September 19, 2025

## **ADDENDUM NO. 1**

### **DNR-250004 GREAT COUNCIL OBSERVATION TOWER**

1587 US-68,  
Xenia, OH 45385

## FOUNDATION PLAN

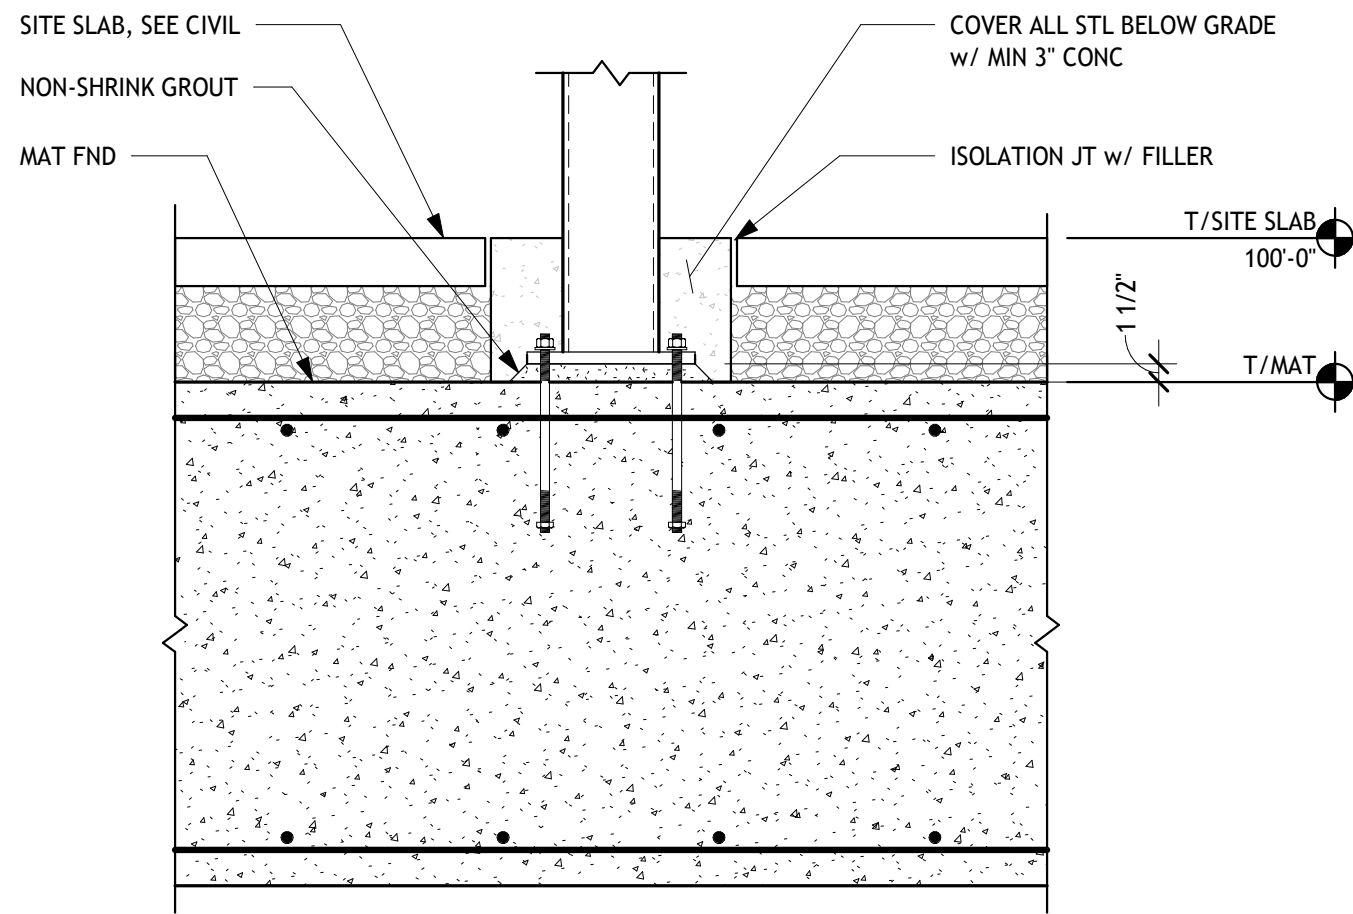
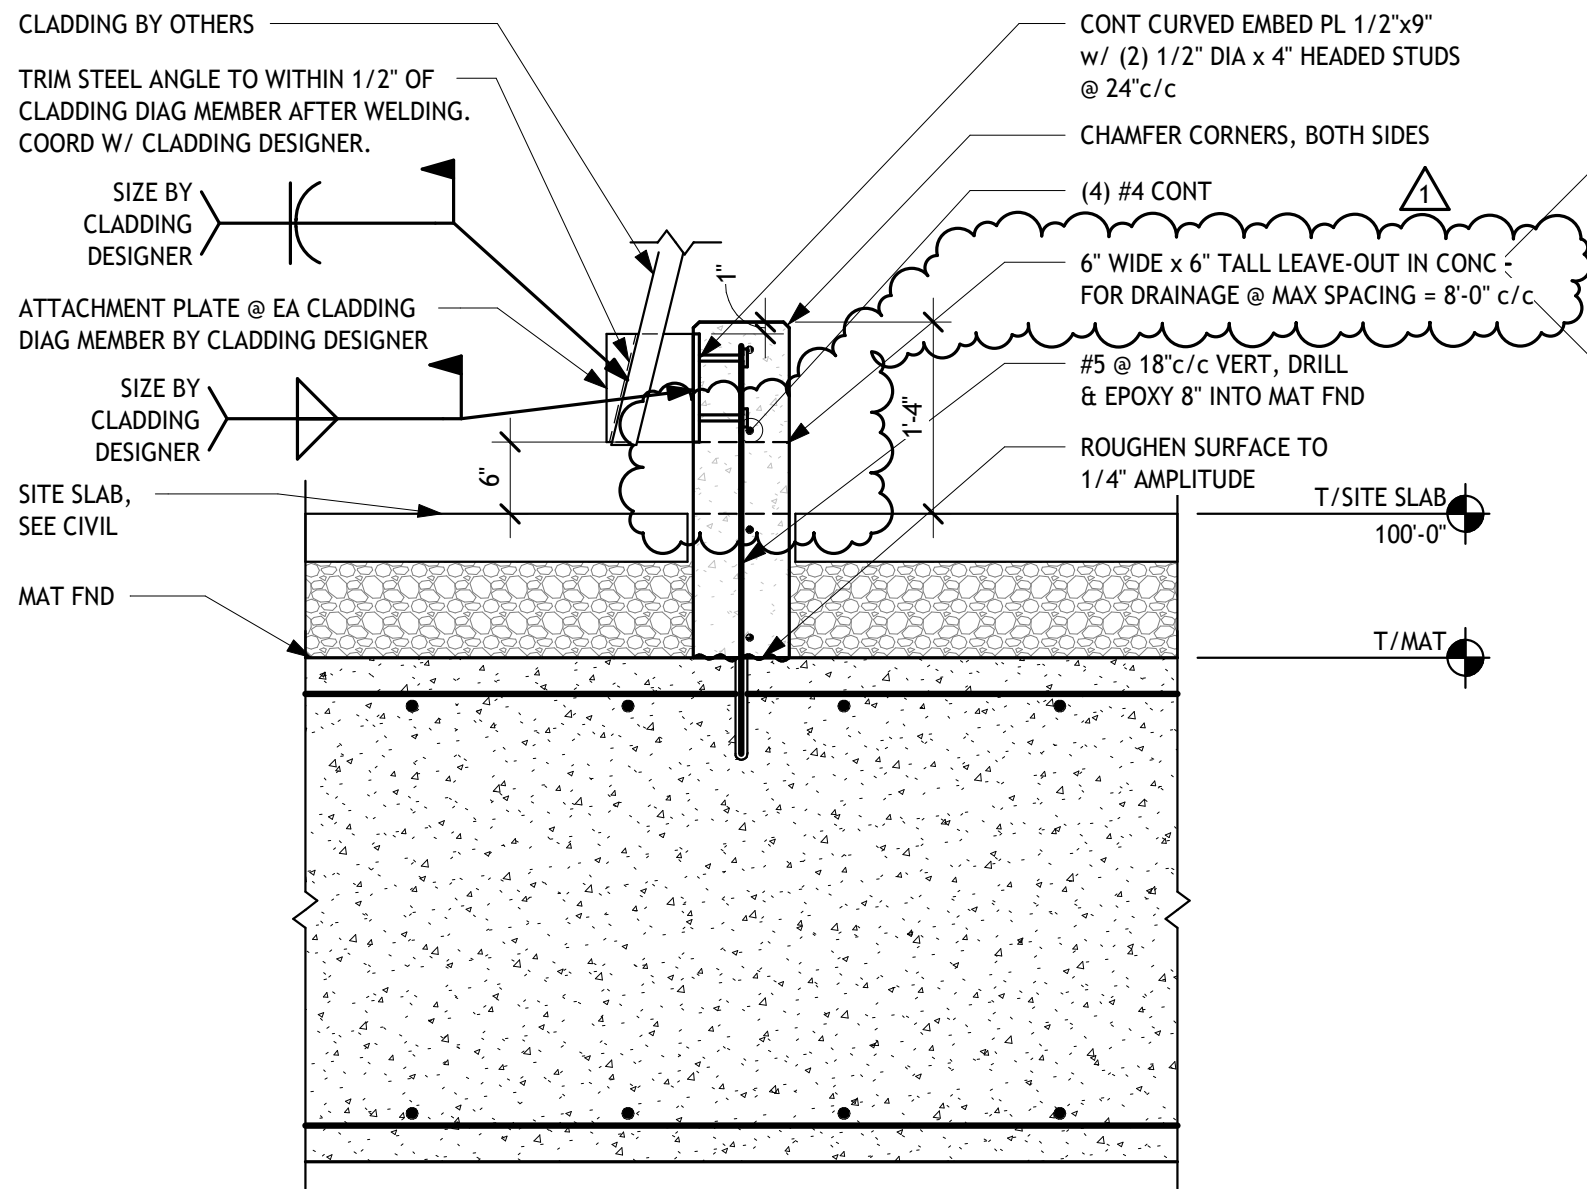
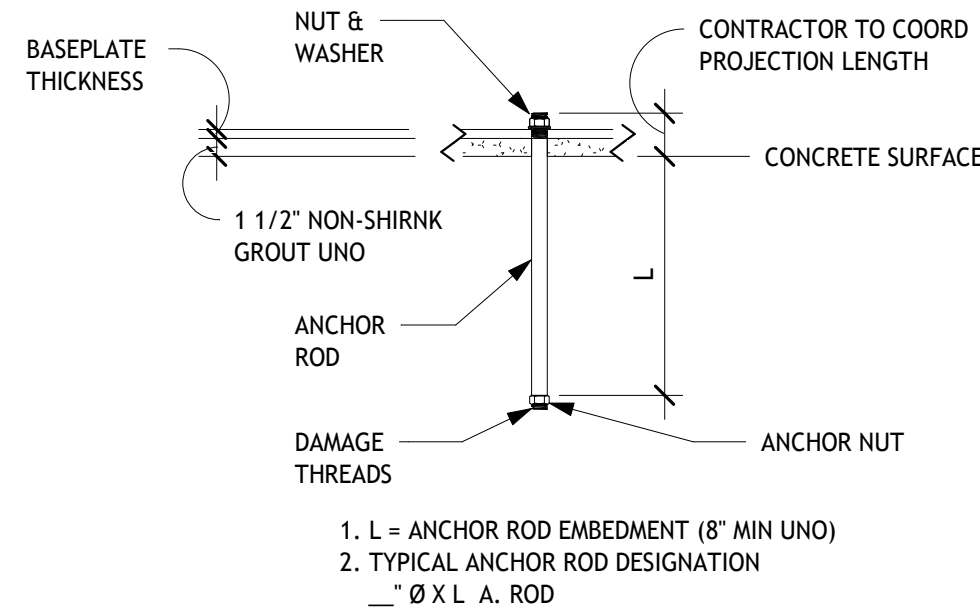
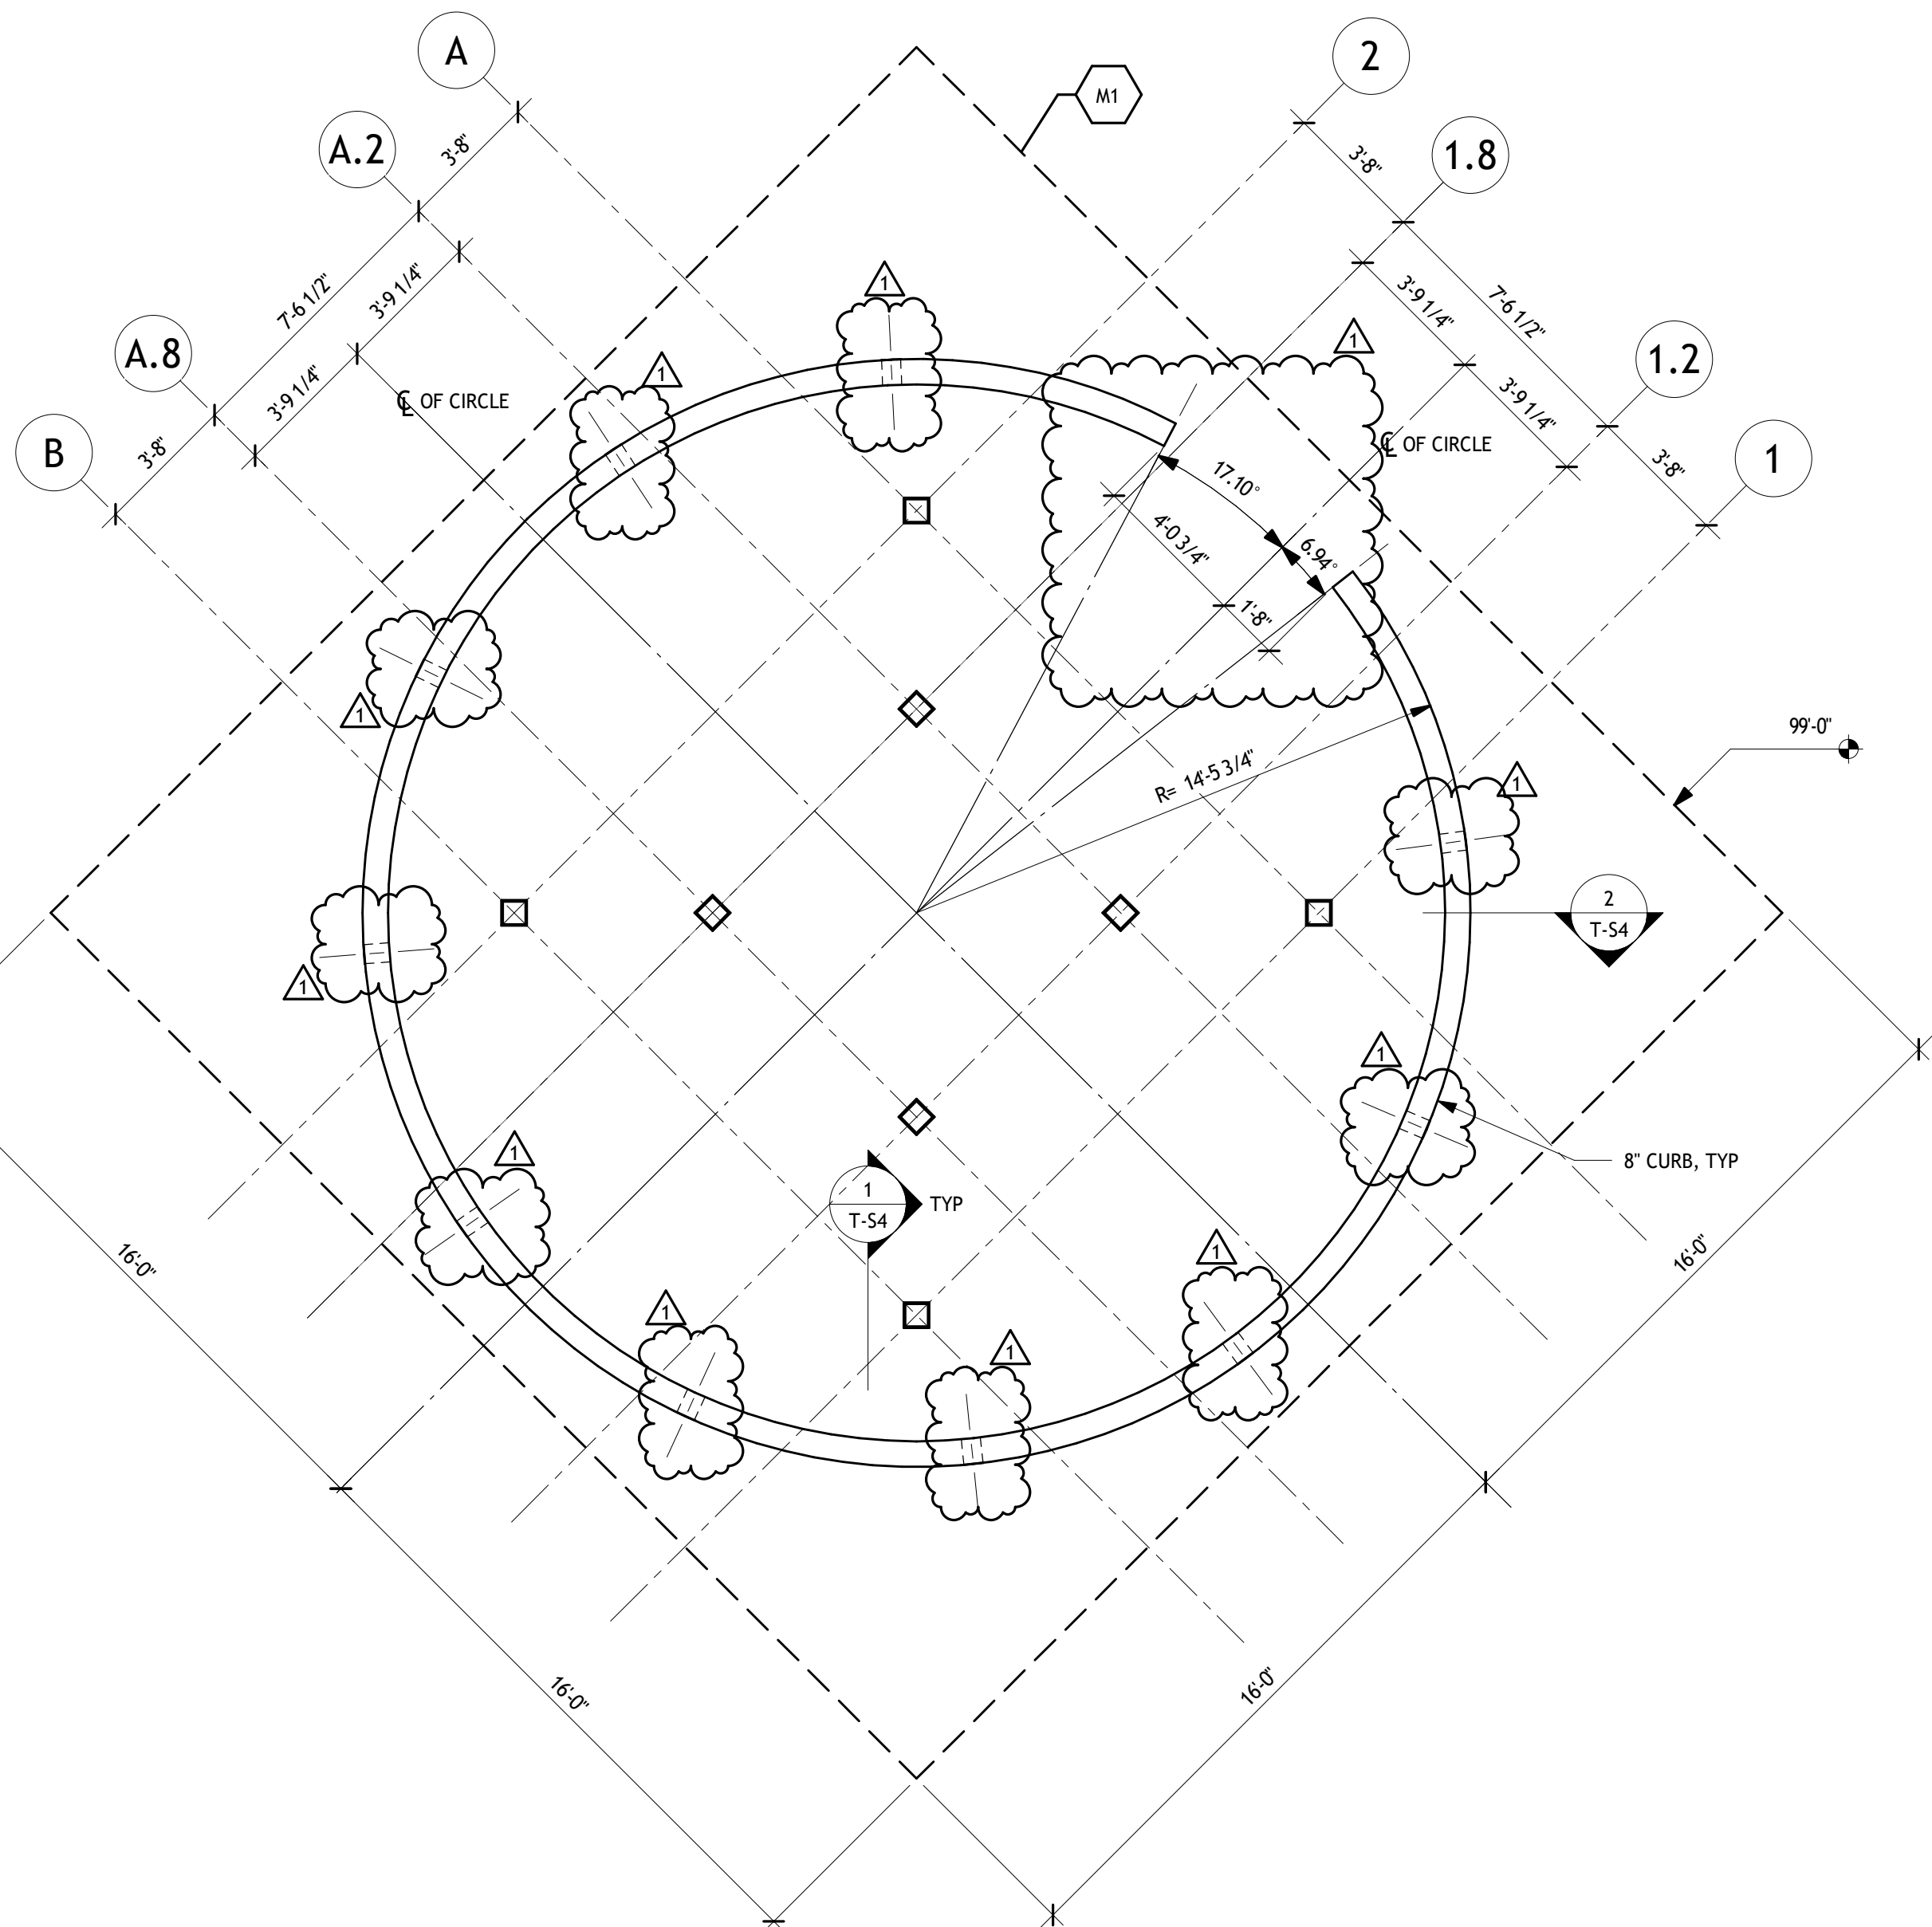
### **ITEM 13 T-S4 – FOUNDATION PLAN & DETAILS**

Added leave-outs at elevation 100'-0" at 8'-0" c/c maximum.
